IMPROVED TECHNICAL SPECIFICATIONS

MONTICELLO NUCLEAR GENERATING PLANT

VOLUMES 1 – 5 REVISION 1

**MONTICELLO
IMPROVED TECHNICAL
SPECIFICATIONS CONVERSION**

Figure 3.1.7-1

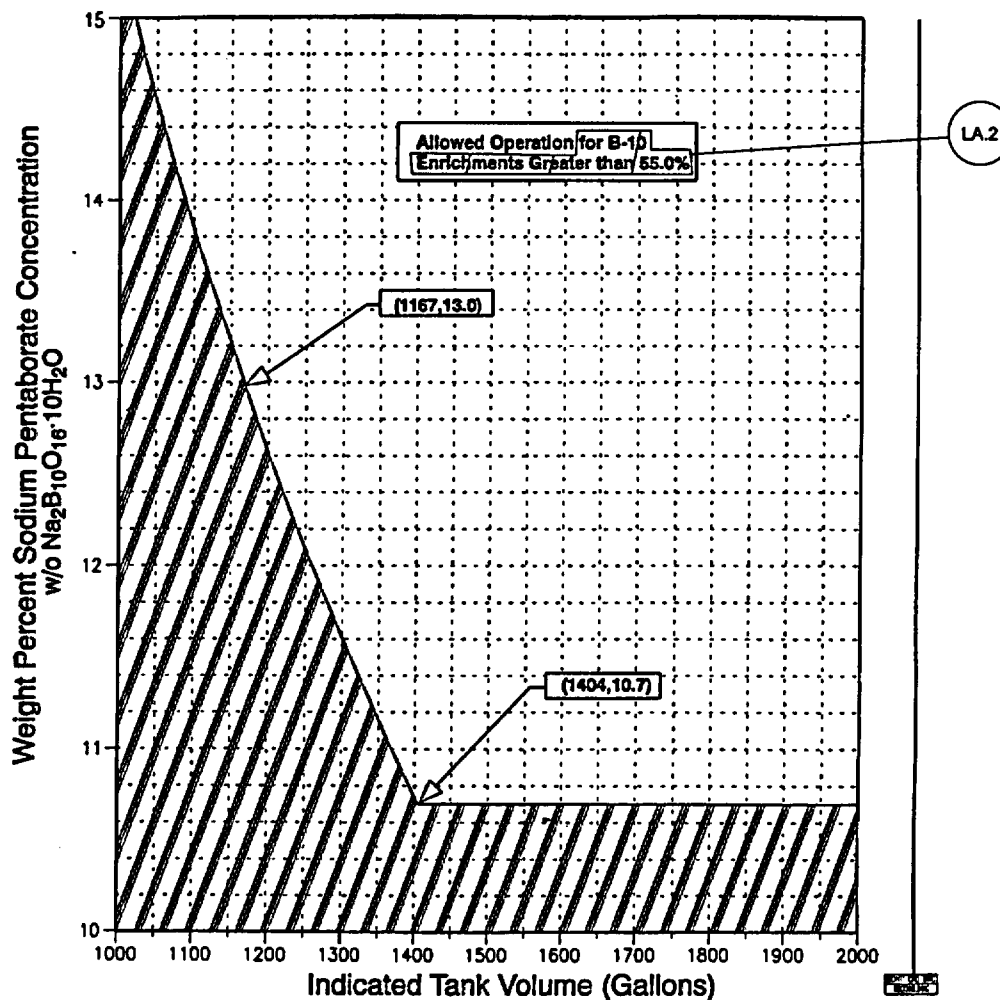
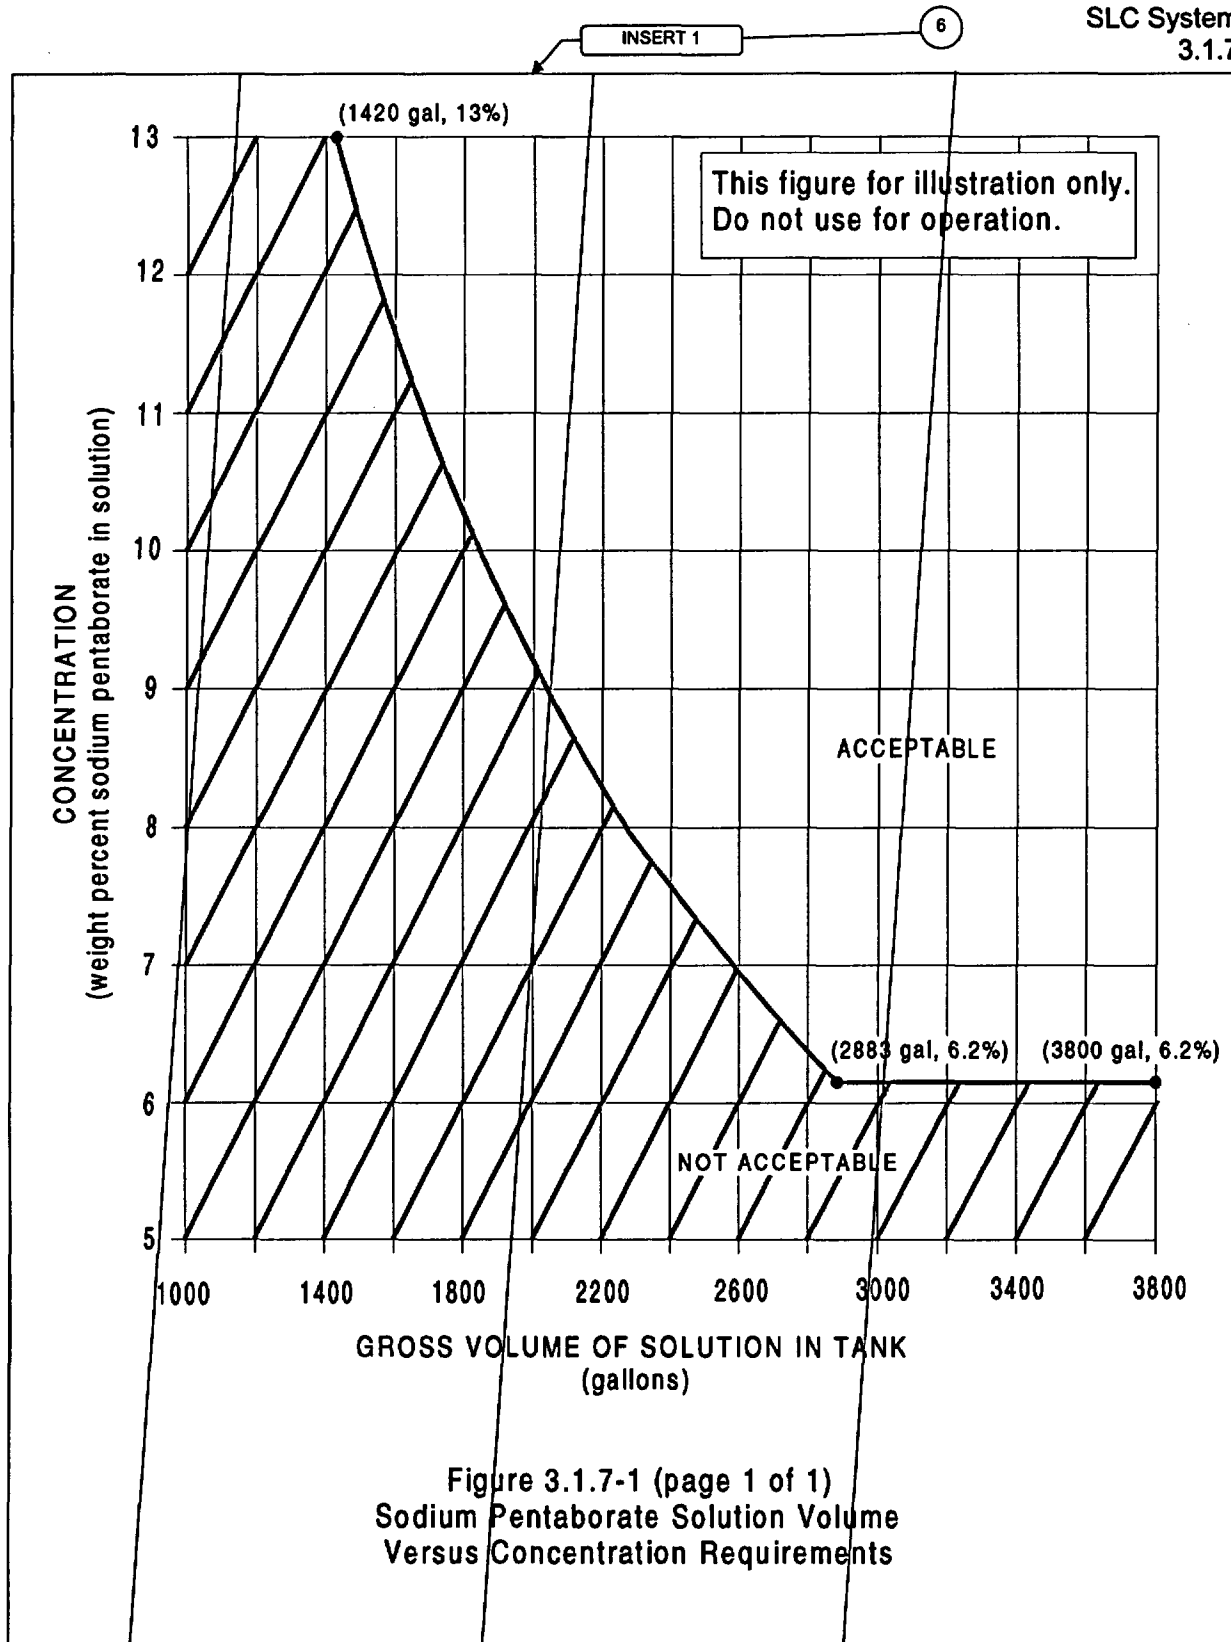
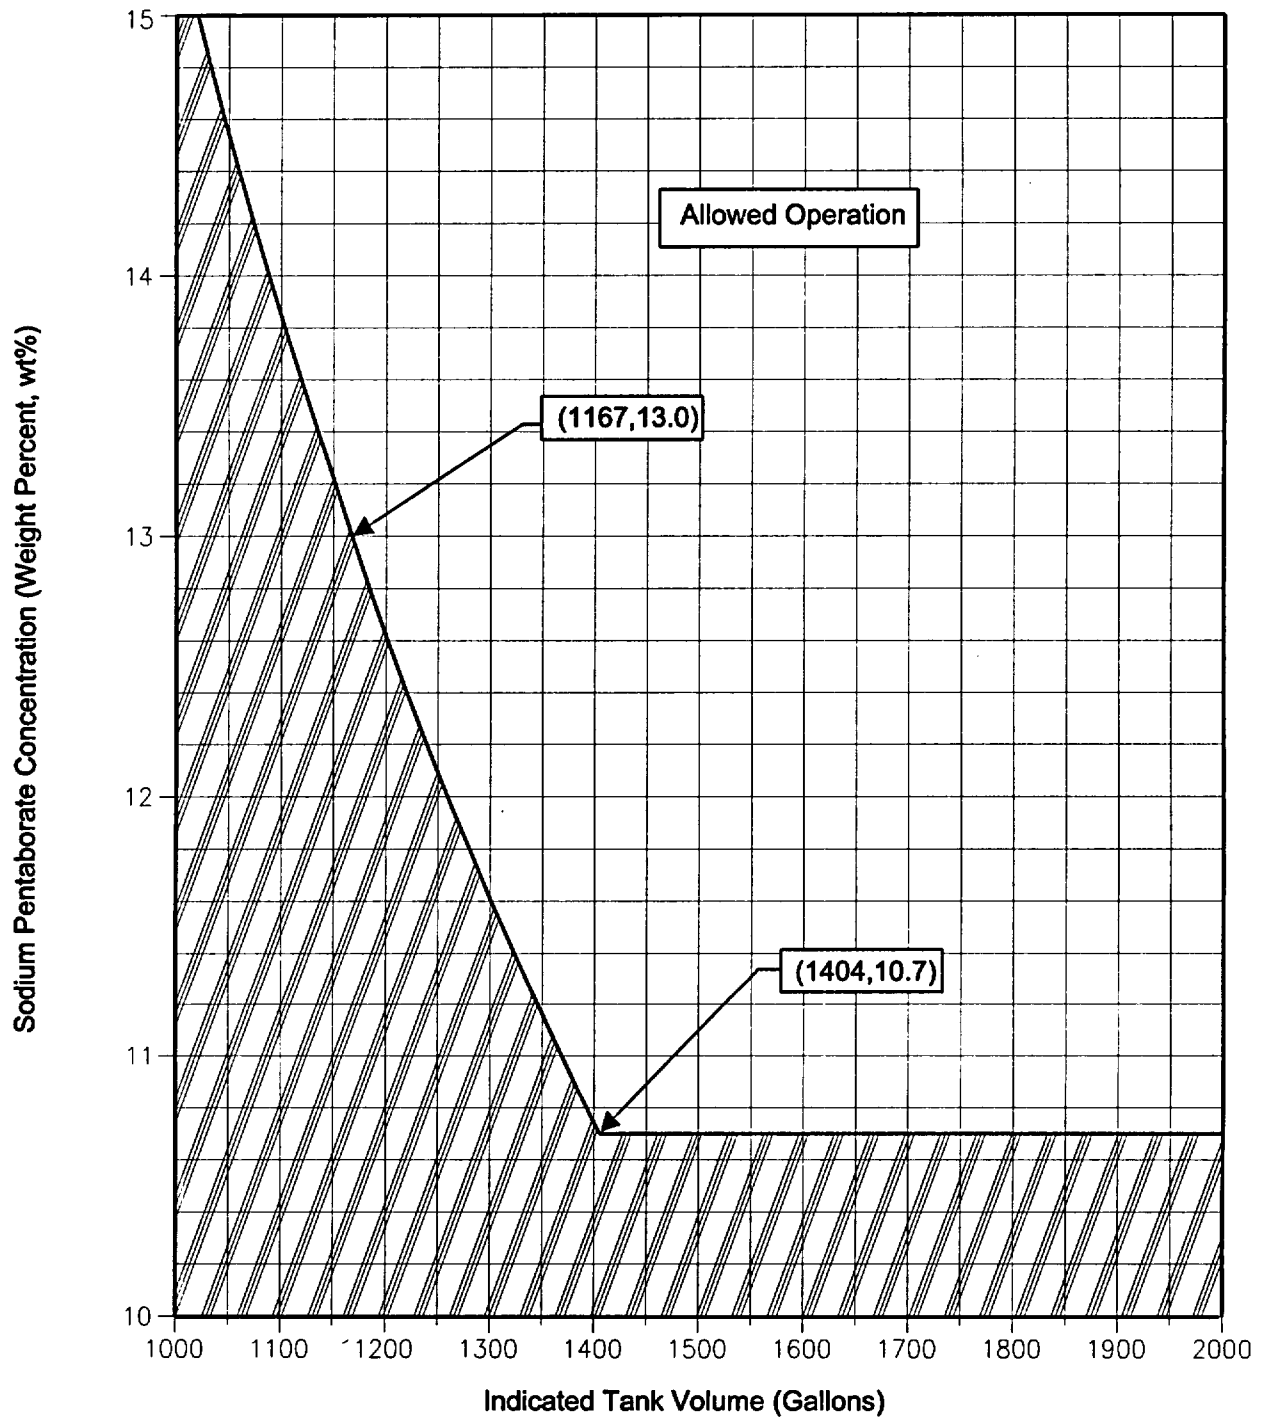
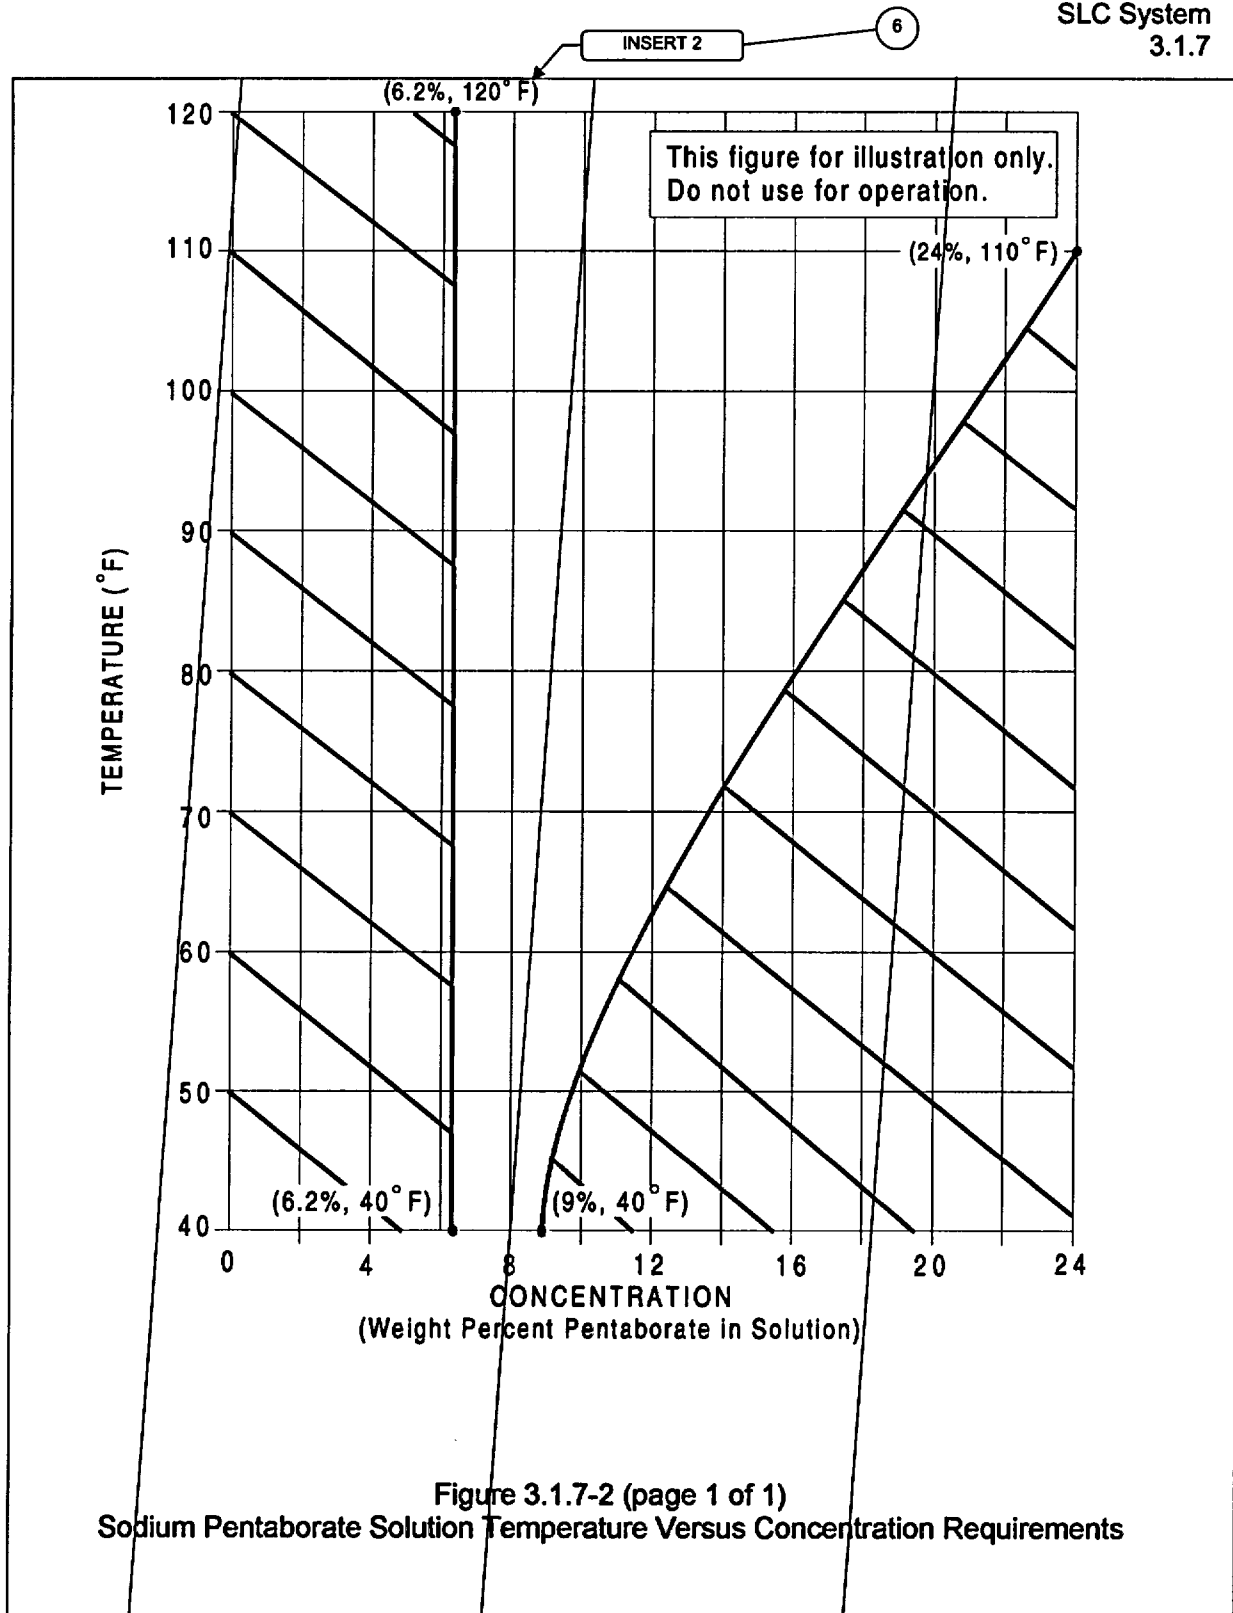
- A.4 CTS 4.4.B.1 requires a determination of boron enrichment, but does not specify the actual limit. The design limit for Monticello is 55.0 atom percent, as stated in CTS Figure 3.4-1. ITS SR 3.1.7.10 requires verification that the sodium

The purpose of CTS 4.4.B.1 is to verify the sodium pentaborate enrichment is within the design limit so that Figure 3.4-1, which is based on a boron enrichment of 55.0 atom percent, can be used. Therefore, this change is acceptable since the limit specified in CTS Figure 3.4-1 is being added to the appropriate Surveillance. This change is considered a presentation preference change only and, as such, is considered an administrative change.

- LA.2 *(Type 1 – Removing Details of System Design and System Description, Including Design Limits)* CTS 3.4.B.1 states Equation 1 is consistent with the "Original Design Basis" and Equation 2 is consistent with the "ATWS Design Basis." CTS Figure 3.4-1 specifies that the curves are based on "B-10 Enrichments Greater than 55.0%." ITS Figure 3.1.7-1 includes the same requirements as

CTS Figure 3.4-1, except the detail concerning the B-10 enrichment. ITS Table 3.1.7-1 includes Equation 1 and Equation 2, however the statements concerning the "Original Design Basis" and "ATWS Design Basis" are not included. This changes the CTS by relocating these details to the ITS Bases.

SURVEILLANCE			FREQUENCY
3.4.B.1, 4.4.B.3.a	SR 3.1.7.1	Verify available volume of sodium pentaborate solution is within the limits of Figure 3.1.7-1 or ≥ 4530 gallons. <small>Equation 1 of Table 3.1.7-1</small>	24 hours (1)

3.4.B.1, 4.4.B.2	SR 3.1.7.5	Verify the concentration of boron in solution is within the limits of Figure 3.1.7-1. <small>or within the limits of Equation 2 of Table 3.1.7-1</small> <small>sodium pentaborate</small>	31 days (1) AND (3) Once within 24 hours after water or boron is added to solution AND Once within 24 hours after solution temperature is restored within the limits of Figure 3.1.7-2 (1)
DOC M.2	SR 3.1.7.6	Verify each SLC subsystem manual power operated, and automatic valve in the flow path that is not locked, sealed, or otherwise secured in position is in the correct position, or can be aligned to the correct position.	31 days (4)

Figure 3.1.7-2

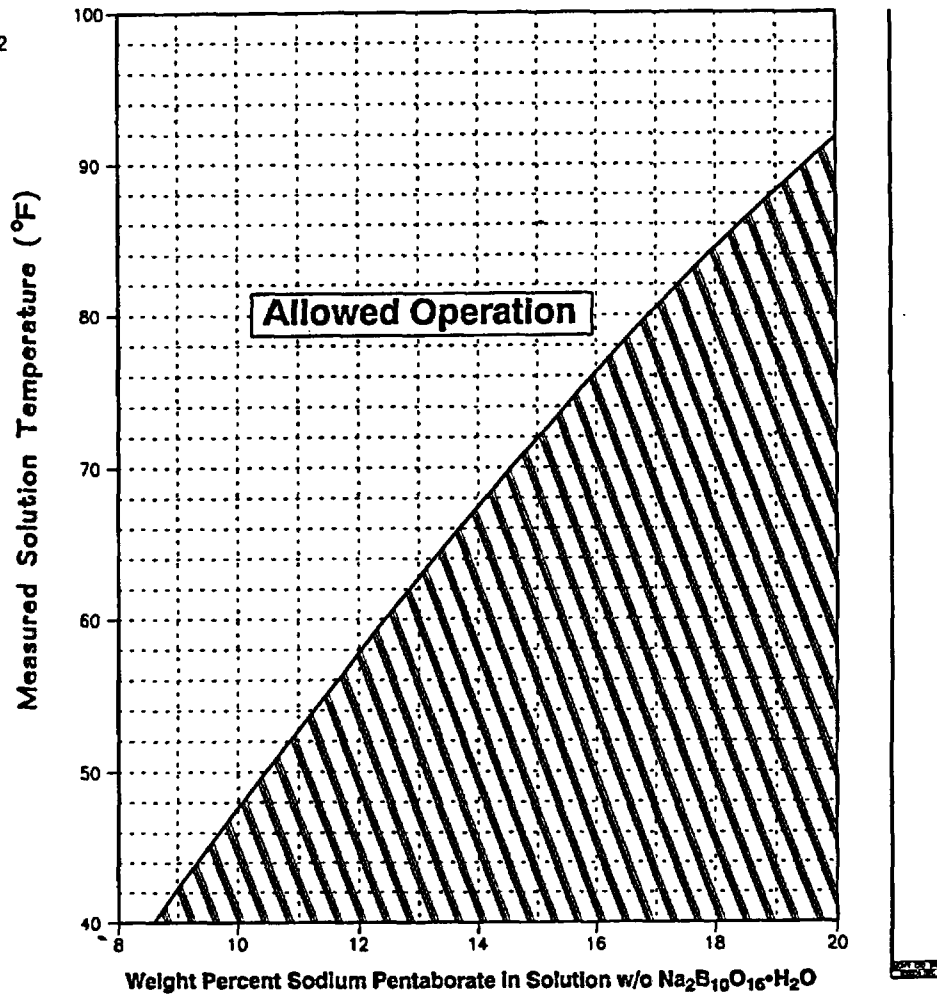
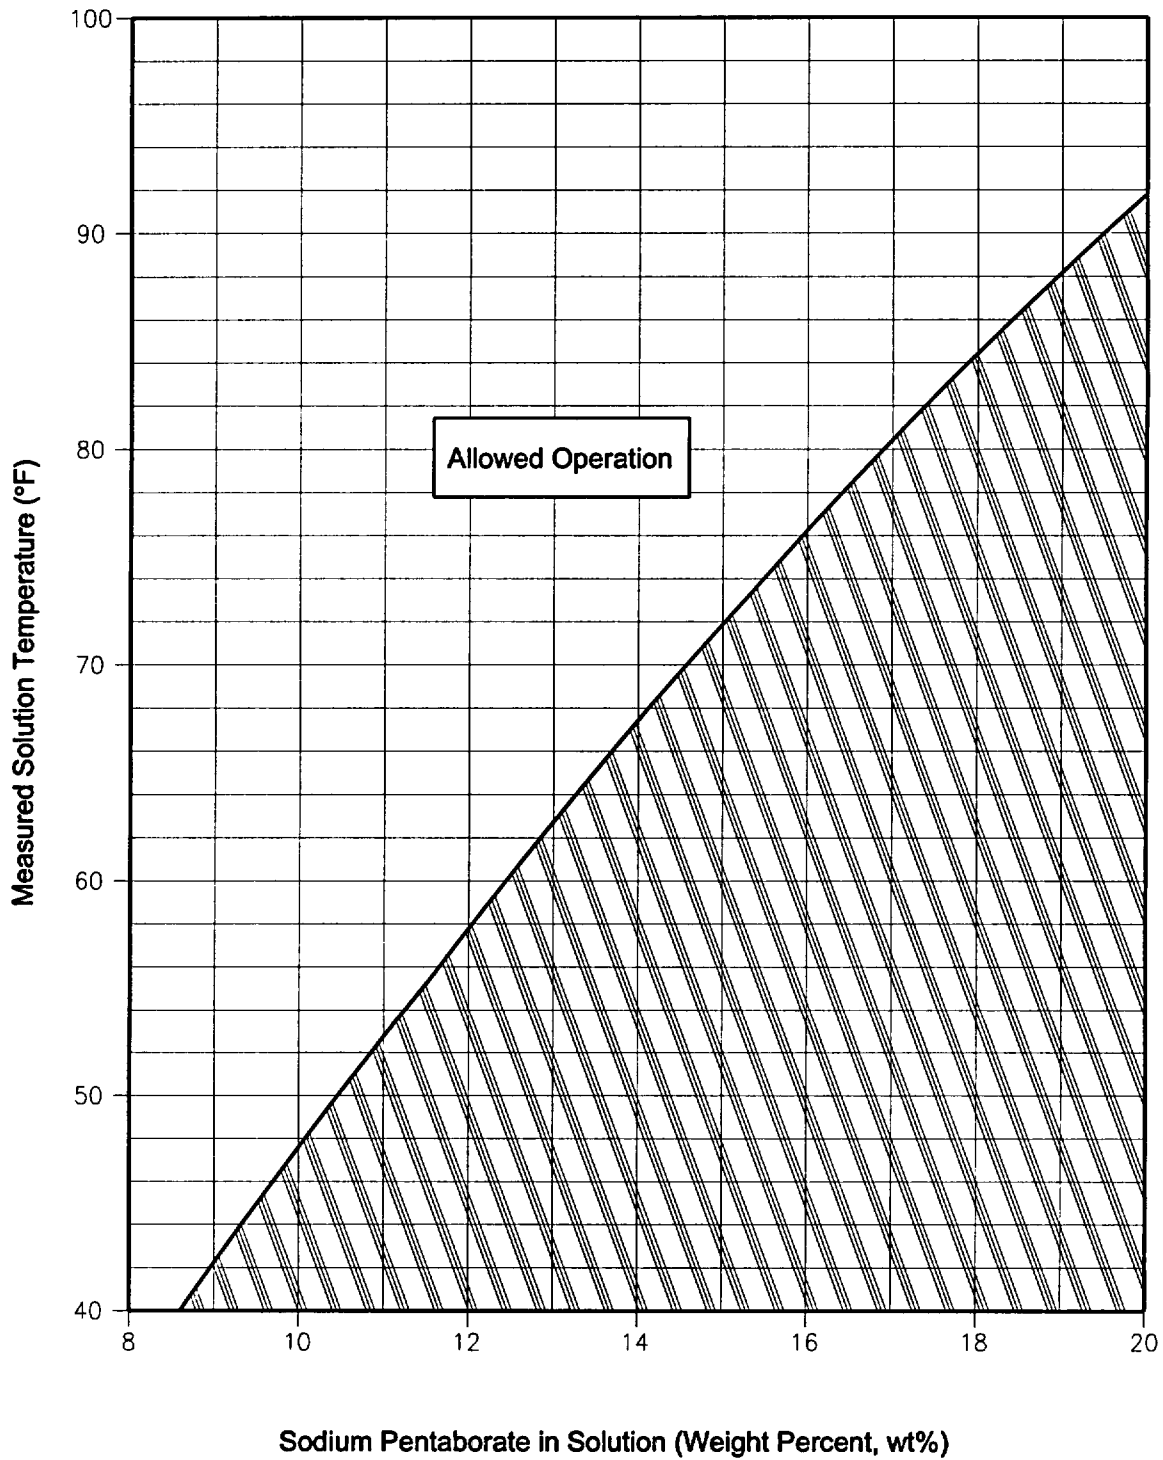
M.4 CTS 4.4.B.2 requires the boron concentration to be determined anytime water or boron is added to the solution or if the solution temperature drops below the limits specified in Figure 3.4-2. However, no finite time to complete performance of this Surveillance is provided. ITS SR 3.1.7.5 requires the same Surveillance; however, a requirement has been added to require the Surveillance to be completed once "within 24 hours" after water or boron is added to the solution and once "within 24 hours after solution temperature is restored" within the limits of Figure 3.1.7-2. This changes the CTS by placing a time limit of 24 hours to perform the Surveillance.

5. ISTS SR 3.1.7.9 requires a verification that all heat traced piping is unblocked once within 24 hours after solution temperature is restored within the limits of Figure 3.1.7-2. A change in solution temperature in the tank does not necessarily have an impact on the piping temperature, as long as the piping heat trace circuit is functioning properly. The intent of the second Frequency is to ensure that, if the heat tracing is inoperable such that piping temperature falls below the specified minimum temperature, after the heat tracing is restored to OPERABLE status and the piping temperature is greater than or equal to the specified minimum temperature the piping is still unblocked. This is supported by the ISTS SR 3.1.7.9 Bases description for this second Frequency, which describes the requirement as required to be performed after piping temperature is restored. However, since the Monticello design does not include temperature indication on the suction piping, the plant-specific requirement for determining piping temperature, by measuring the room temperature in the vicinity of the SLC pumps, will be used in the Frequency. Thus the second Frequency has been changed to once within 24 hours after "room temperature in the vicinity of the SLC pumps" is restored within the "solution temperature" limits of Figure 3.1.7-2. This plant-specific requirement concerning the room temperature is shown in CTS 3.4.B.3.c and 4.4.B.3.c. Furthermore, a Note has been added stating that the second Frequency is only required if the SLC pump suction lines heat tracing is inoperable, consistent with the above discussed intent.

3.4.B.2, 4.4.B.3.b	SR 3.1.7.2	Verify temperature of sodium pentaborate solution is within the limits of Figure 3.1.7-2.	24 hours (1)
3.4.B.3, 4.4.B.3.c	SR 3.1.7.3	Verify temperature of pump suction piping is within the limits of Figure 3.1.7-2. <small>or verify SLC pump suction lines heat tracing is OPERABLE</small> <small>room in the vicinity of the SLC pumps</small>	24 hours (1)
DOC M.2	SR 3.1.7.4	Verify continuity of explosive charge.	31 days
